ADDENDUM #01

Project No.:	16-0017	Date:	March 20, 2020
Project:	Portage Public Schools Existing Central Middle School Demolition	A/E Firm:	C2AE
		Project Manager:	Thomas McKercher, AIA
Owner:	Portage Public Schools 8135 S Westnedge Avenue Portage, MI 49002

SOUTH SITE IMPROVEMENTS
 AND GEOMETRICS PLAN

SCALE: AS SHOWN
 PROJ #: 160017
 DATE: 2018.08.13
 SHEET
C-108
 RFT 1001

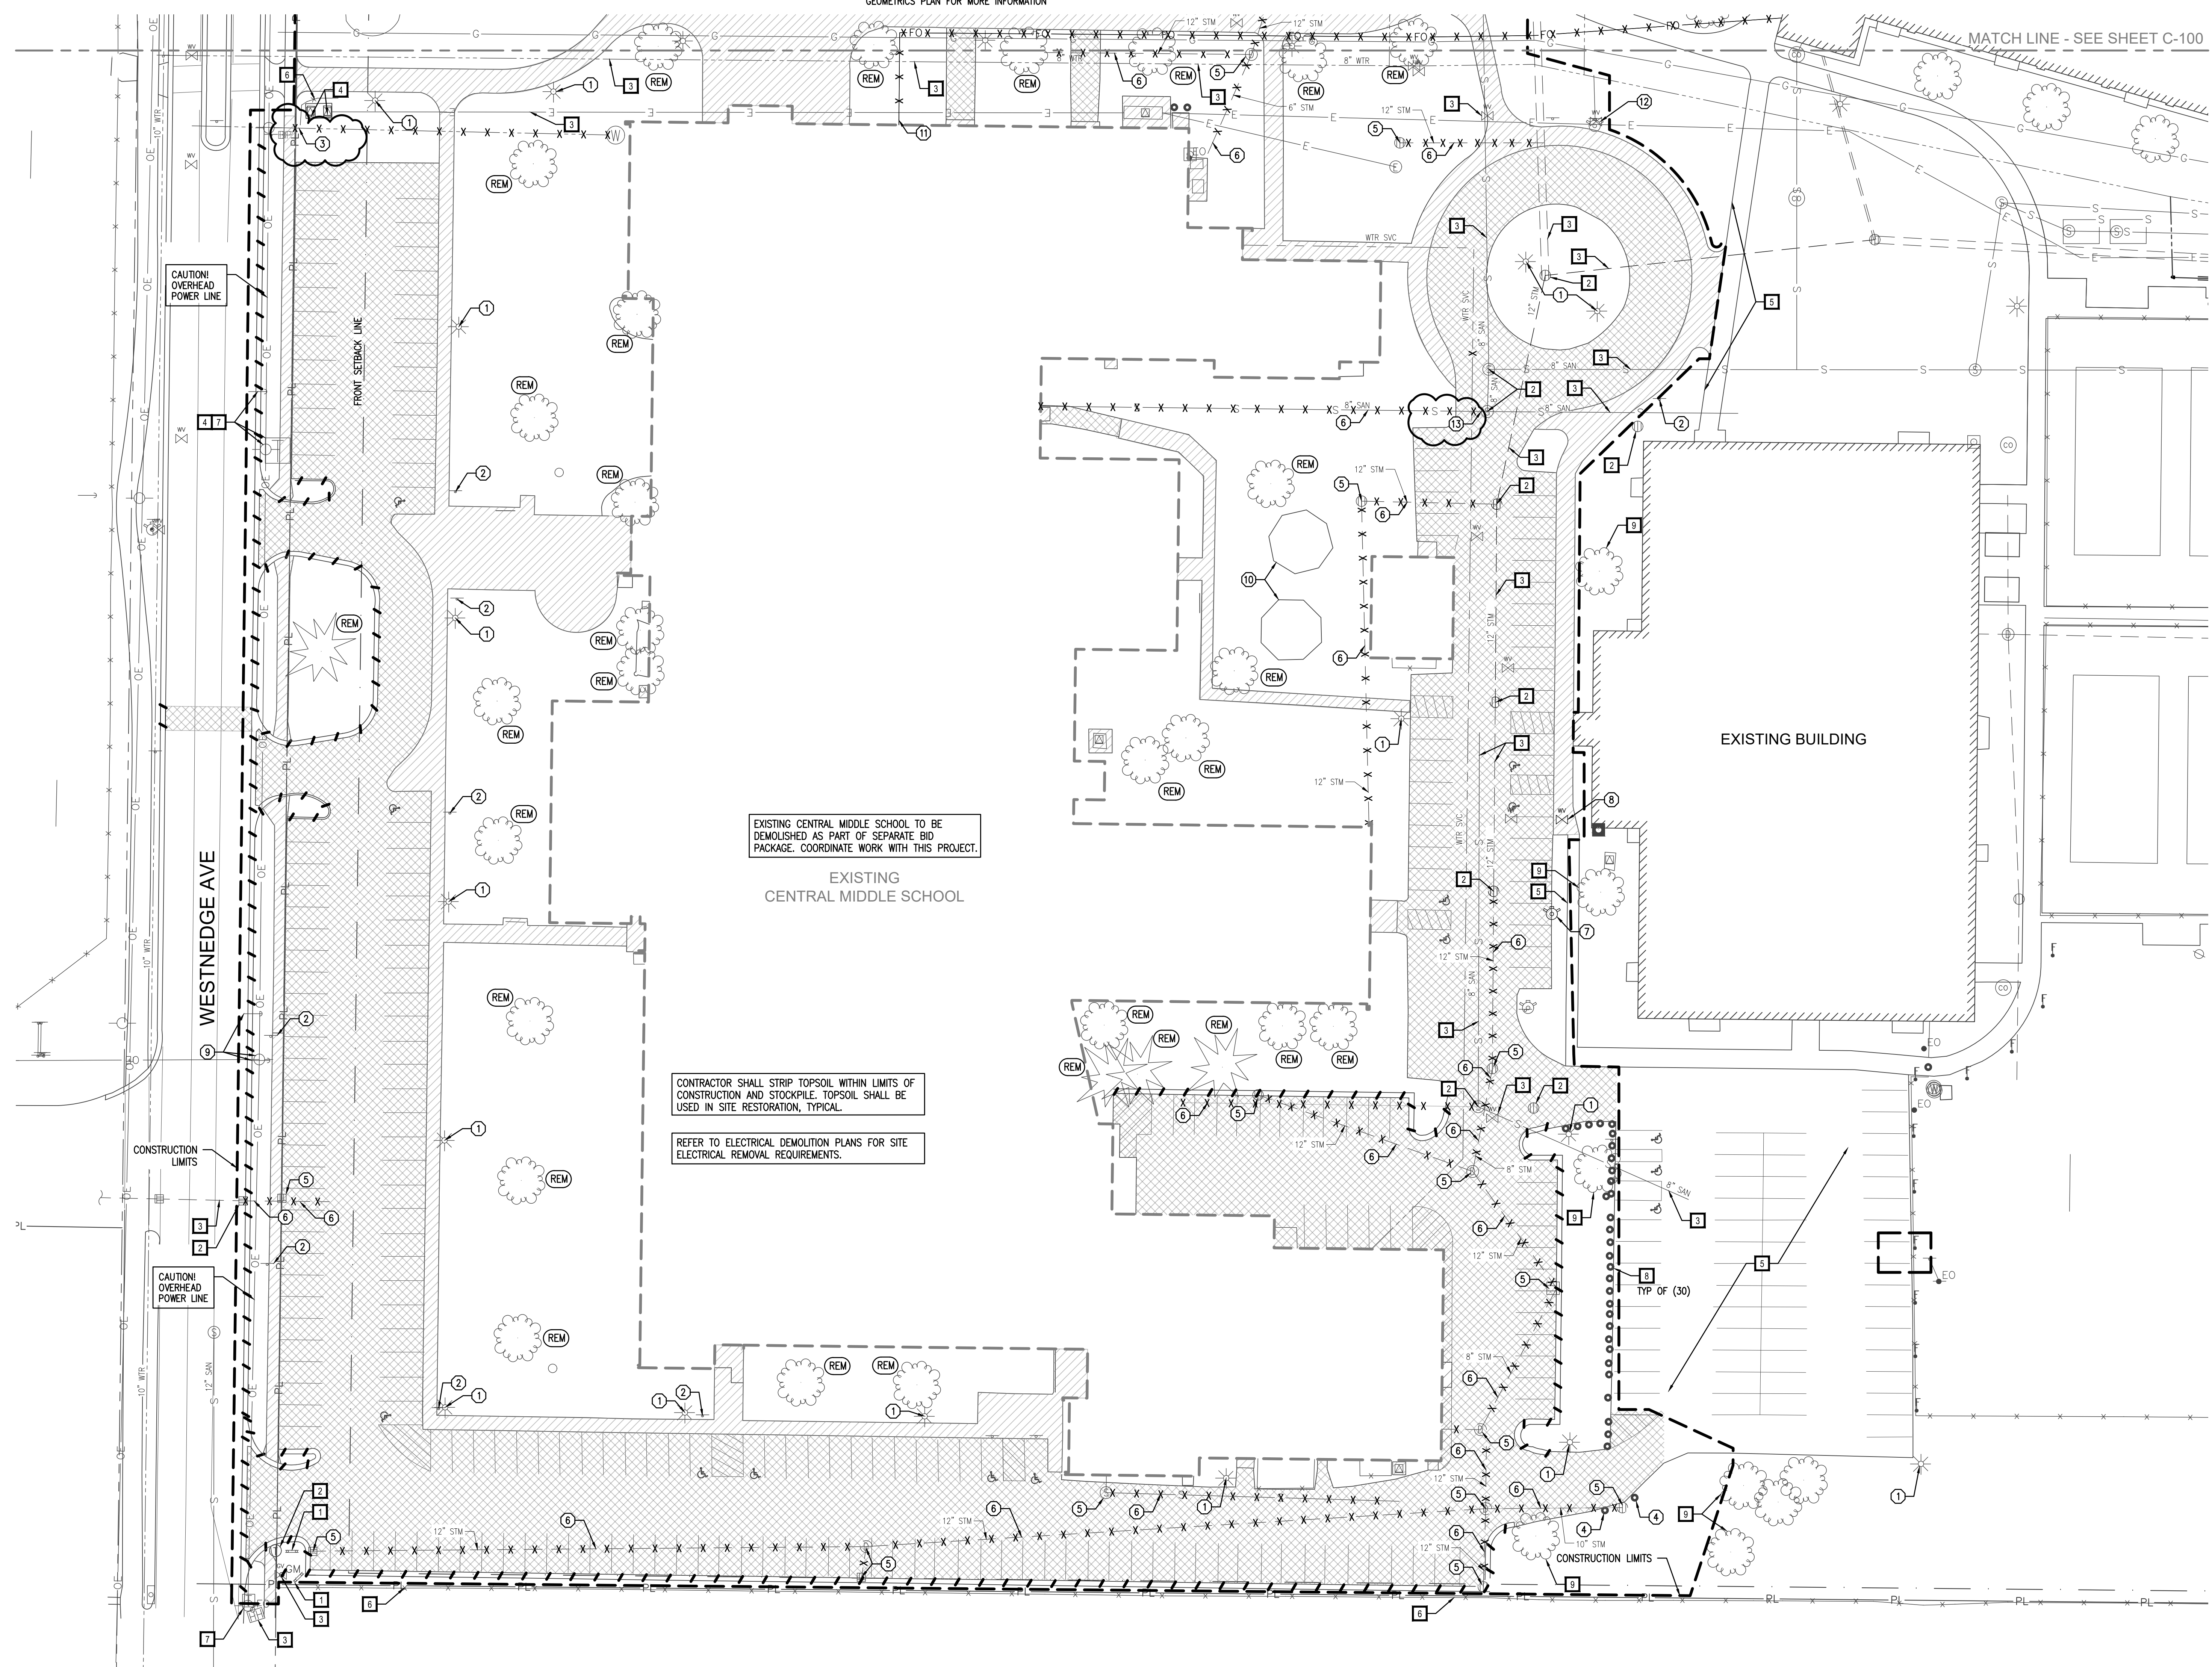
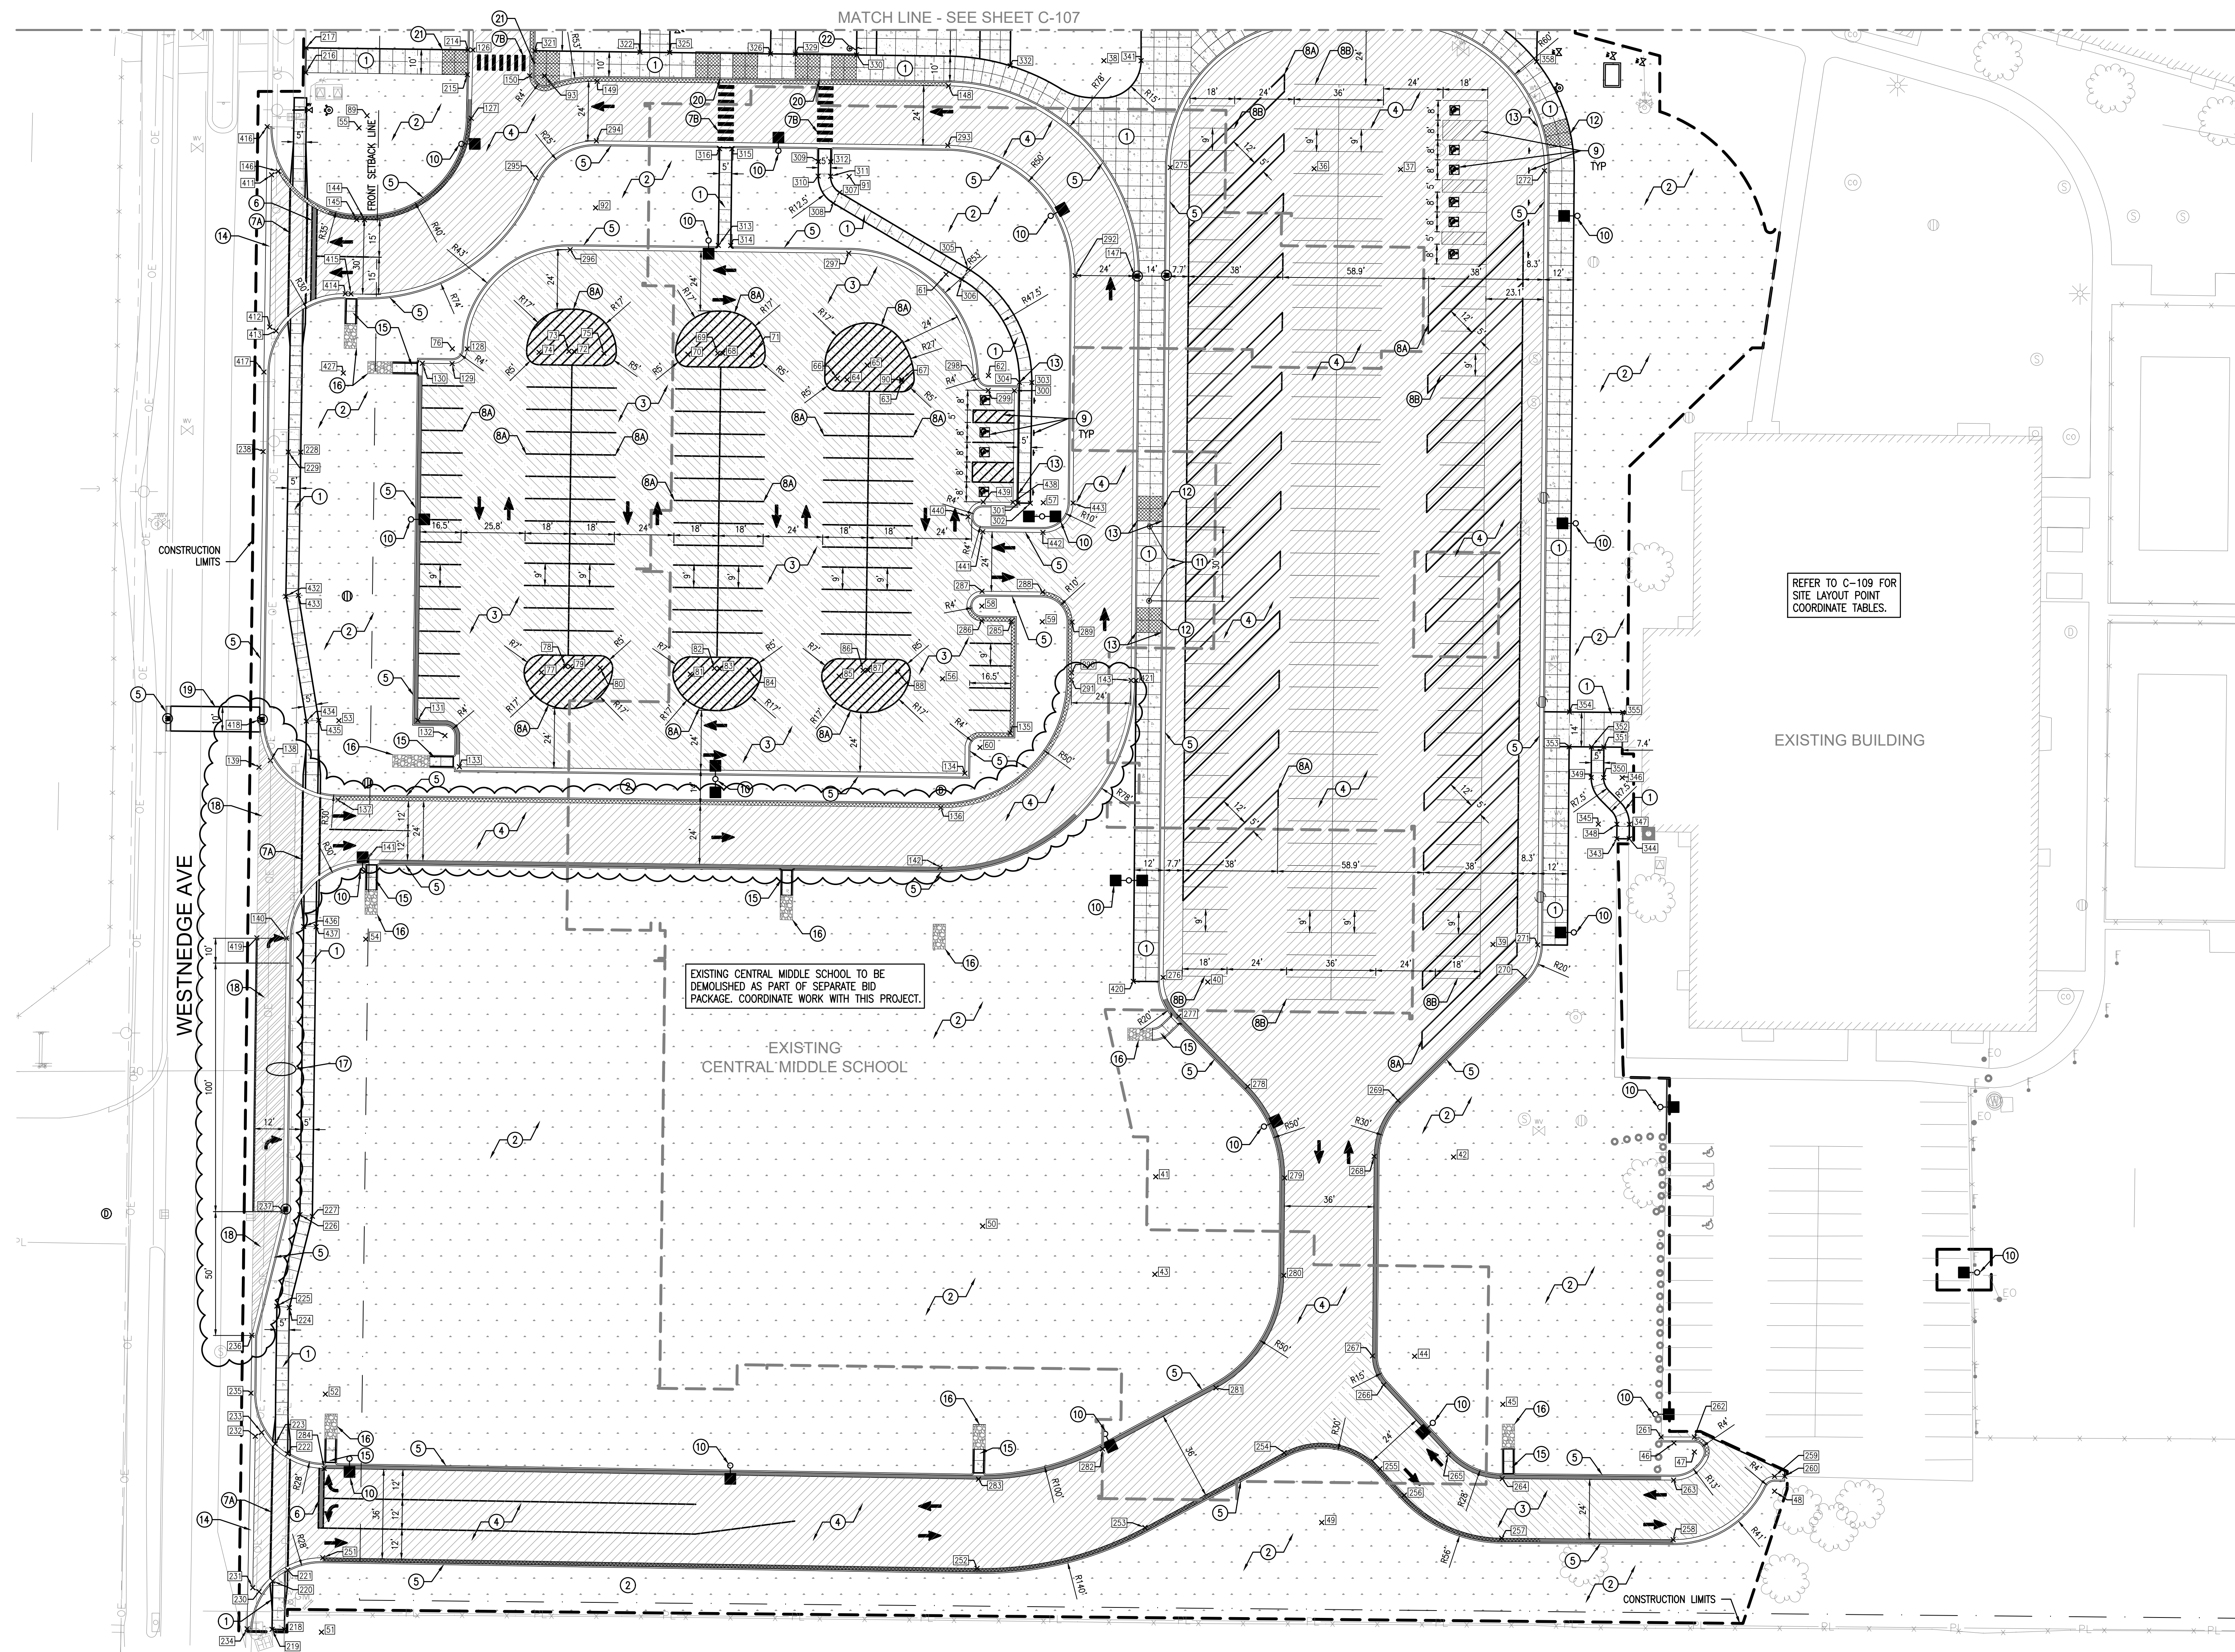
Question - On Dwg C108 there appears to be a Deceleration lane, can you tell me where this starts & ends, how far does this go into the drive? Also it is labeled as Light Duty HMA, Im assuming you want the HMA that is called out on DWG: C302 (Westnedge Ave Deceleration Lane section), is that correct?

On Dwg C108 heading East from the deceleration lane, the "lines" indicate Light Duty HMA, however, the number indicates Heavy Duty. What do you want in this area?

Response - The deceleration lane pavement section starts at coordinate point 236 and extends north to coordinate point 418. The deceleration lane is 12' wide and extend slightly east to the property line as it extends north through the bus drive. The drawing has been updated to show a new hatch pattern for the deceleration to graphically clarify the extents. The deceleration lane pavement section has its own, unique requirements as shown on detail 8, sheet C-302.

The bus drive, heading east from the deceleration lane, is to be heavy duty pavement. The drawing hatch pattern has been updated to reflect this.

See attached Revised Sheet C108
